ADDENDUM

PROJECT: University of South Dakota
Patterson Hall
Mechanical / Electrical Infrastructure Upgrades
Vermillion, South Dakota

AD-1

DATE ISSUED: Thursday, January 22, 2015

1 Enlarged Second Floor Plan
Scale: 1/4" = 1'-0"

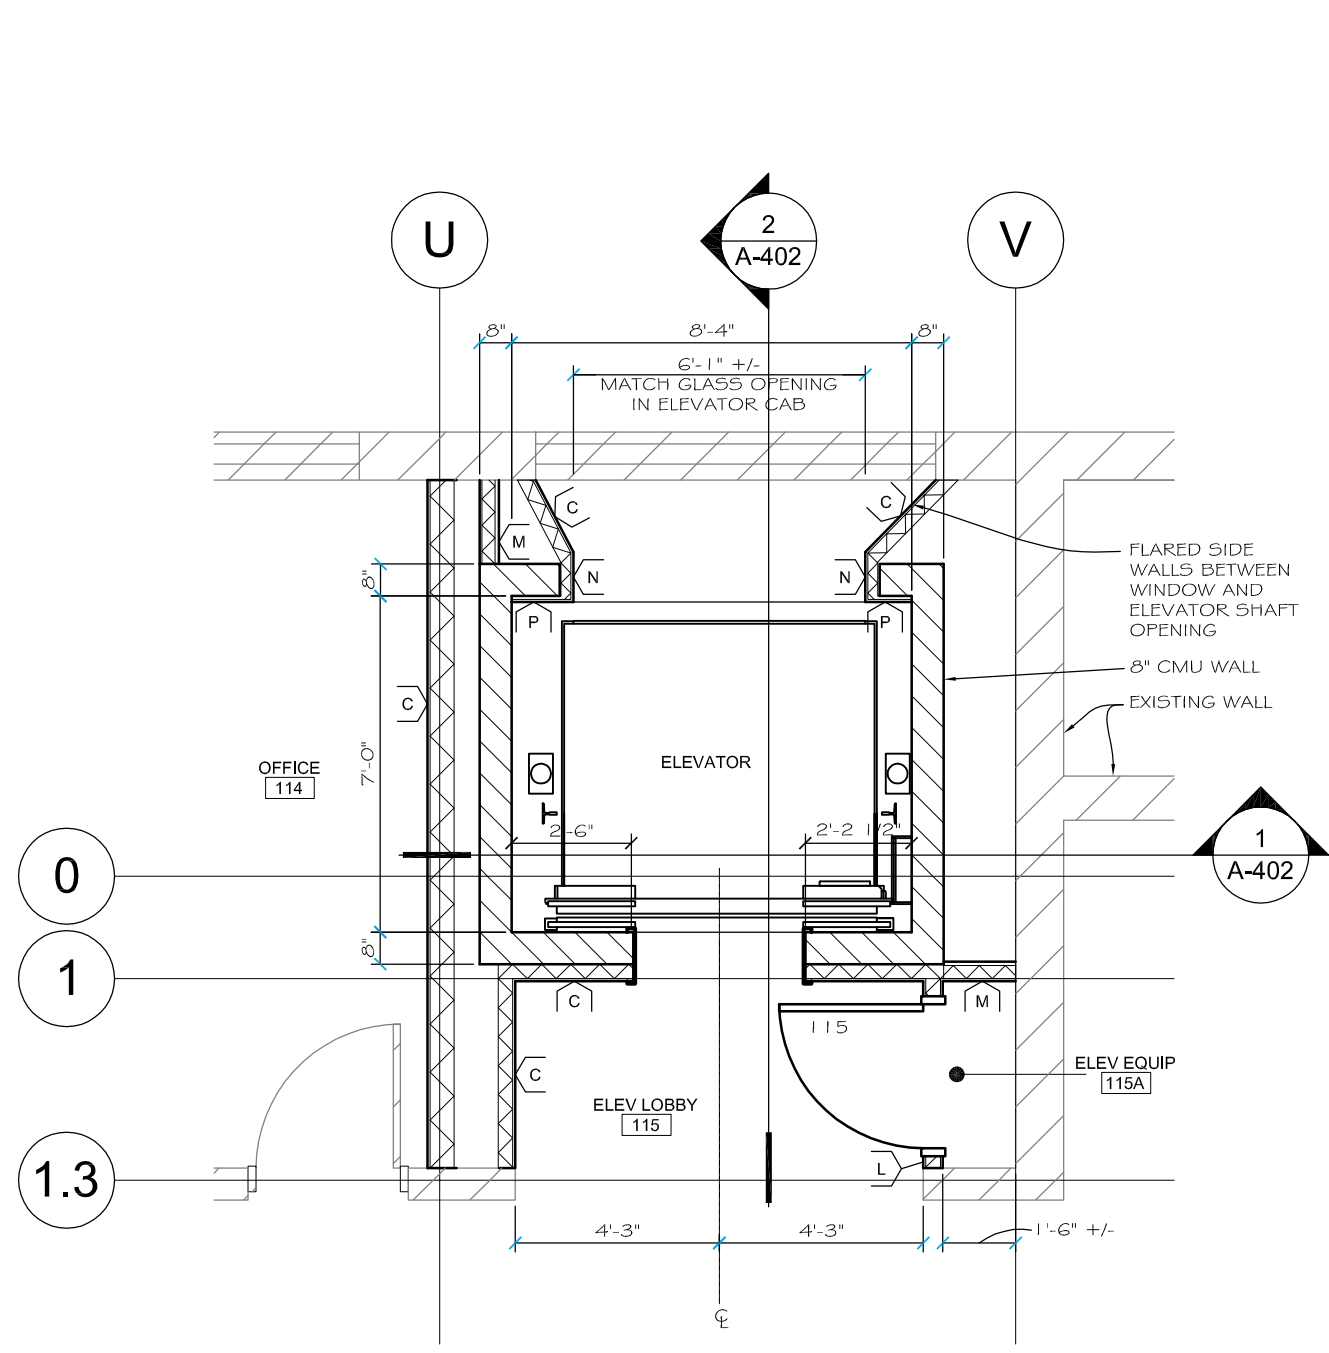
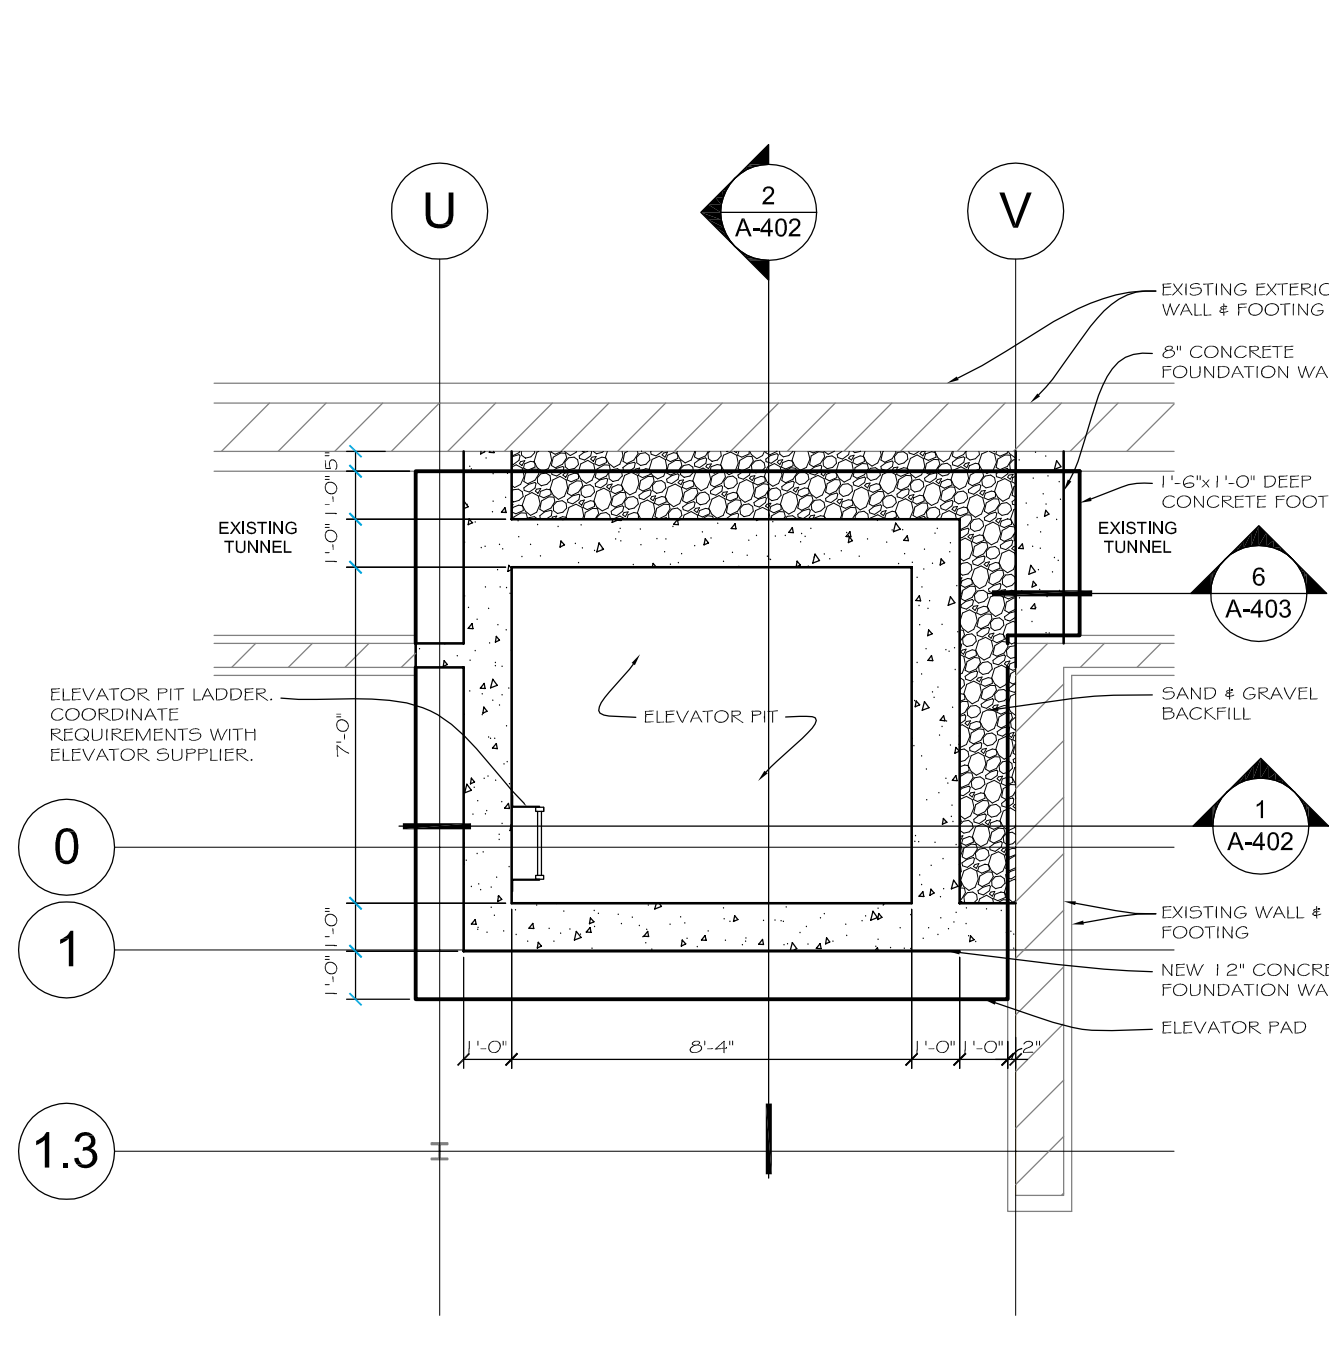
In reference to Sheet A-403, see attached revised sheet.
